平陆县 100MW 农光互补光伏发电项目
监理工程师通知单

编号: ZHJL-JLTZ-PL-199

主题: 2025 年 4 月 15 日监理单位及总包单位在阳朝 25、26、27 地块复验收过程中发现以下问题:

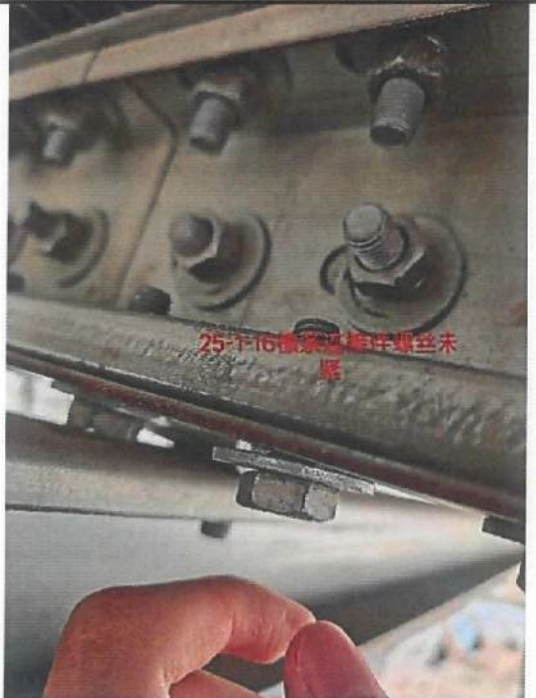
5	 25-1-6 缺少对穿	6	 25-1-6 桥架跨接线断裂
7	 25-1-16 桥架盖板未关闭 (通病)	8	 25-1-16 桥架盖板螺栓未紧
9	 25-1-20 缺少斜撑	10	 25-1-28 缺少斜撑 (与之前一样)

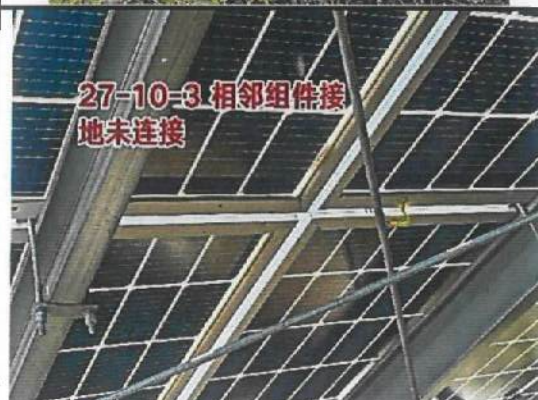
23	 27-10-8左上角组件接 地线未连接	24	 27-10-5u型螺栓单螺 母
25	 27-10-12 u型螺栓单 螺母	26	 27-10-12 缺少斜撑
27	 27-10-13 檩条连接件 缺少螺栓	28	 27-10-13 u型螺栓单 螺母 缺弹、平垫
29	 27-10-13 压块与组件 缝隙过大	30	 25-1逆变器处横梁 防火封堵破损
